Southern Nuclear Operating Company
Vogtle Electric Generating Plant Units 3 and 4 Combined License Application
Response to Request for Additional Information Letter No. 030

Enclosure: Response to NRC RAI Letter No. 030 on the VEGP Units 3 & 4 COL Application
Involving Lateral Earth Pressures and Hydrostatic Pressures at the Site

**Response to NRC RAI Letter No. 030
on the VEGP Units 3 & 4 COL Application**

**Involving
Lateral Earth Pressures and Hydrostatic Pressures
at the Site**

Figure 2.5-201 – Vogtle Site-Specific At-Rest Lateral Earth Pressure Diagrams for Rigid Below Grade Nuclear Island (NI) Walls

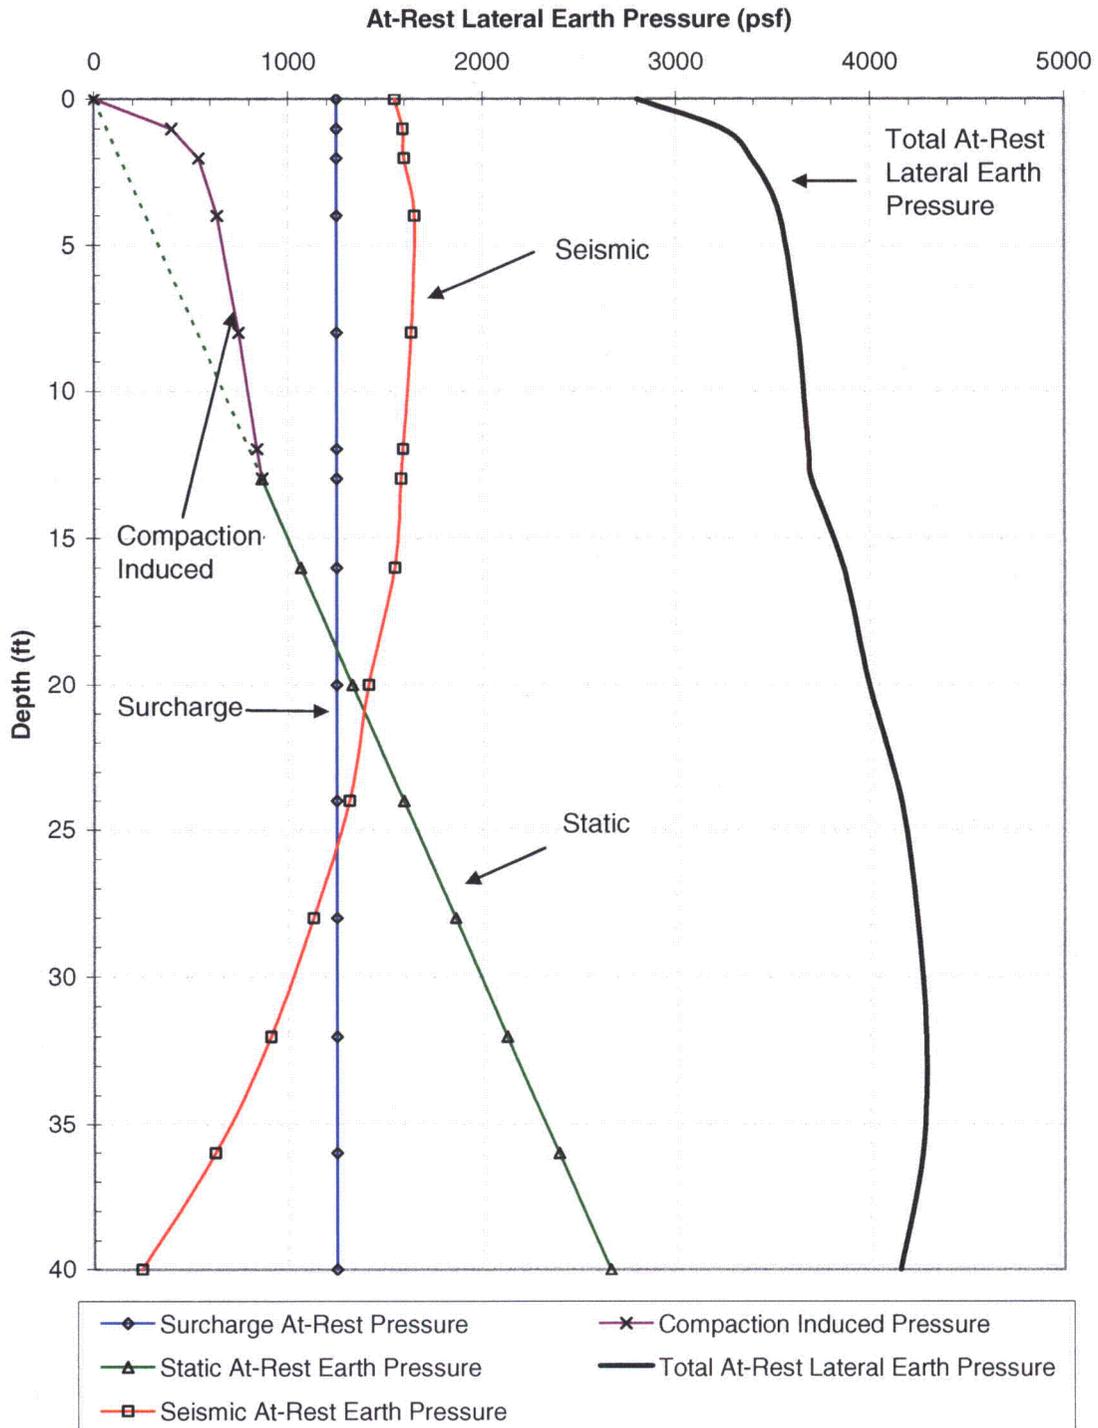
SSAR Section 2.5.4 does not include a discussion of the lateral earth pressures or hydrostatic pressures at the site. RAI 2.5.4-1 requested an explanation of the methodologies used to determine the lateral earth pressures and the hydrostatic pressures acting on the safety-related structures at the VEGP Units 3 and 4 site. The response to RAI 2.5.4-1 stated that the static lateral earth pressures were evaluated using Rankine's theory for active, at-rest, and passive conditions; seismic lateral earth pressures for active and at-rest conditions were evaluated using methods presented by Mononobe-Okabe and ASCE 4-98, respectively; and lateral earth pressures resulting from an areal surcharge applied at the ground surface alongside below-grade walls were evaluated for active and at-rest conditions. Sample earth pressure diagrams for active and at-rest conditions were provided.

- 1) It appears the ASCE 4-98 reference for at-rest conditions is not for the case of Rankine at-rest conditions but rather refers to the Wood solution for dynamic pressures against a rigid wall, as Figure 2 of the response to the RAI resembles the Wood dynamic pressure solution. It is not obvious how this relates to the at-rest pressure conditions, as an at-rest condition is associated with a static overburden condition where pressures increase with depth due to dead weight of the soil under a presumed zero displacement assumption of the wall.

Please address each of the concerns listed above and provide justification for the use of or any reference made to wall pressure calculations discussing active soil pressures conditions employing the Mononobe-Okabe method.

The site-specific at-rest lateral earth pressure diagram for rigid walls (at-rest case) is presented in new FSAR Figure 2.5-201 (enclosed). A saturated unit weight of 133 pcf for the backfill was used to calculate static and dynamic earth pressures. The site-specific at-rest pressure diagram presented utilizes the ASCE 4-98 elastic solution method to evaluate dynamic earth pressures, which is appropriate for rigid walls. Figure 2.5-201 also includes lateral earth pressure components attributed to a conservatively chosen vertical areal surcharge of 2,500 psf (using a k_0 of 0.5 results in a lateral surcharge pressure of 1,250 psf). This Vogtle site specific lateral surcharge pressure of 1,250 psf envelops the AP1000 maximum lateral static plus dynamic design surcharge pressures. Figure 2.5-201 also includes static earth pressures and compaction-induced pressures. A summation of components is presented in Figure 2.5-201 as the total at-rest lateral earth pressure. Groundwater is located well below the basemat elevation at the VEGP Units 3 and 4 site; thus hydrostatic pressure is not included in the site-specific earth pressure diagrams.

In summary, Figure 2.5-201 presents the site-specific total at-rest lateral earth pressures for the below grade NI rigid walls. This diagram was developed assuming level ground surface, a post-construction groundwater level below the basemat elevation (no hydrostatic pressure), an areal surcharge pressure of 2,500 psf, and compaction-induced pressure increases. Figure 2.5-202 presents the comparison of the site-specific total at-rest lateral earth pressure distribution compared to the AP1000 DCD design envelope in both the N-S and E-W directions. In both cases, the site-specific at-rest earth pressure is enveloped by the DCD design earth pressure envelopes by significant margins.

Figure 2.5-202 – Comparison of Vogtle Site-Specific Total At-Rest Lateral Earth Pressure Diagrams and AP1000 Maximum Design Envelopes

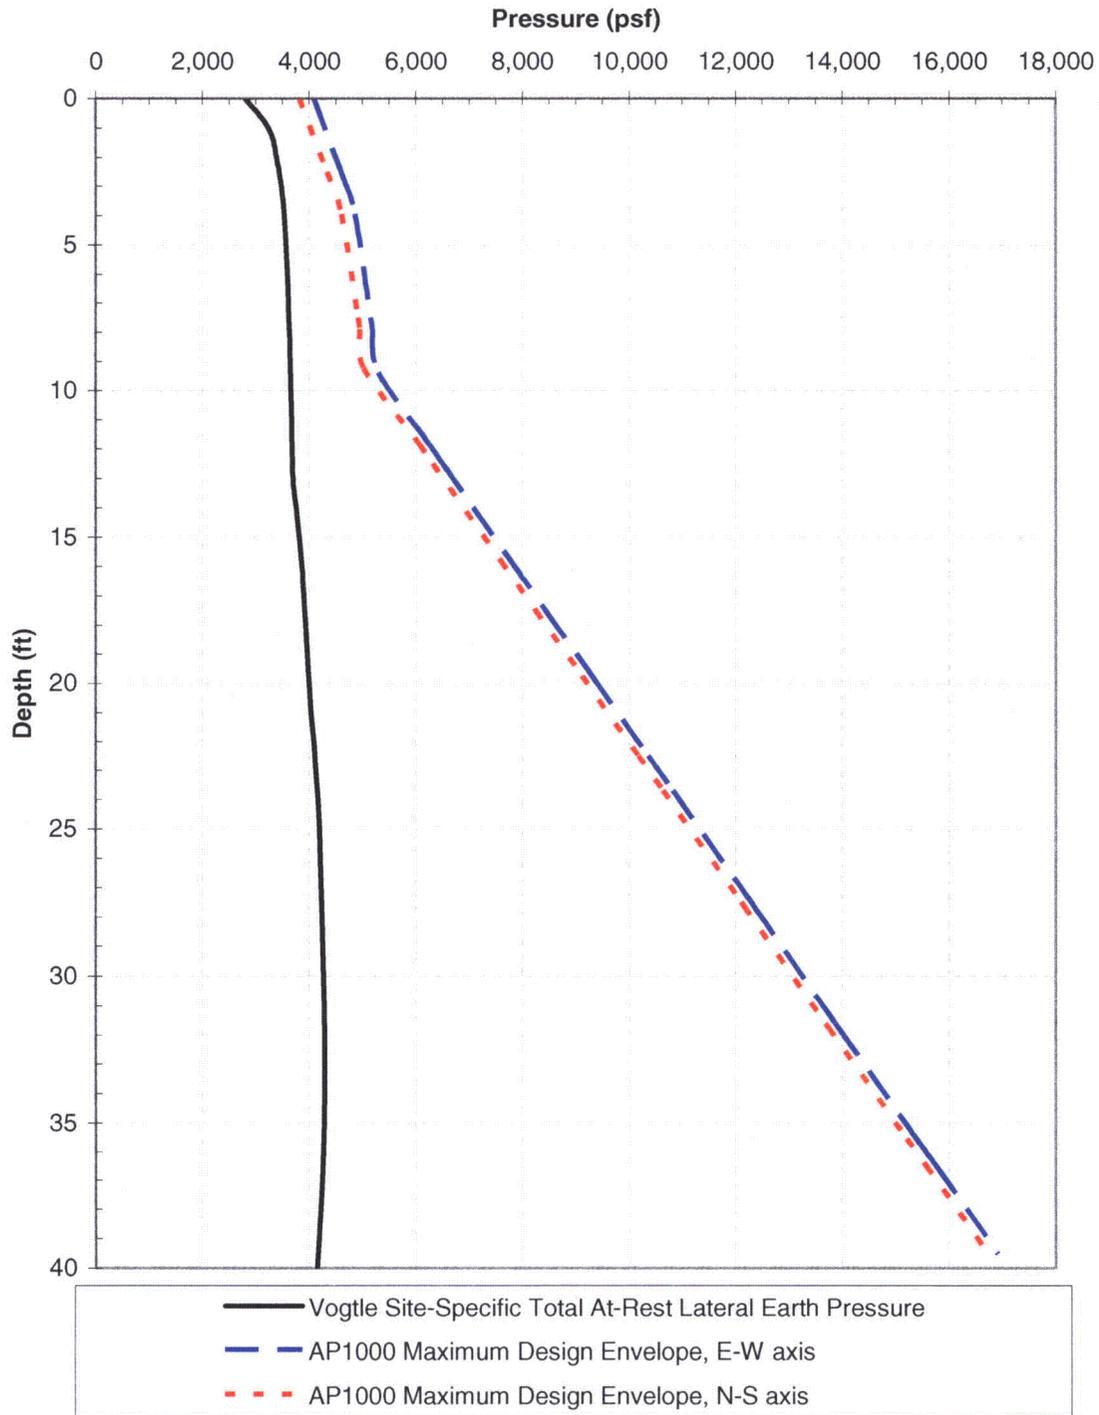
- 4) The AP1000 exterior walls of the nuclear island were designed to resist the envelope of both the dynamic Wood solution and the peak passive pressure solution. The envelope pressure may be very much larger than the M-O solution, particularly along the lower two-thirds of the wall. The lateral seismic pressures acting on the vertical walls will be generated in SASSI and are typically approximated by the Wood solution.

In new FSAR Figure 2.5-202 (enclosed), the site specific at-rest total lateral earth pressures, as presented in Figure 2.5-201 for the safety related NI walls, are compared to the enveloping lateral earth pressures for the AP1000 DCD (design case for the below grade NI walls), as provided by Westinghouse Electric Company (WEC). The AP1000 enveloping pressure diagram includes evaluation of the following earth pressure components:

The AP1000 DCD enveloping design pressures shown on Figure 2.5-202 are the maximum lateral earth pressure in the north-south (N-S) and east-west (E-W) directions. The result is a design lateral earth pressure that envelops the site-specific earth pressures at all depths of the NI walls, in both the N-S and E-W directions.
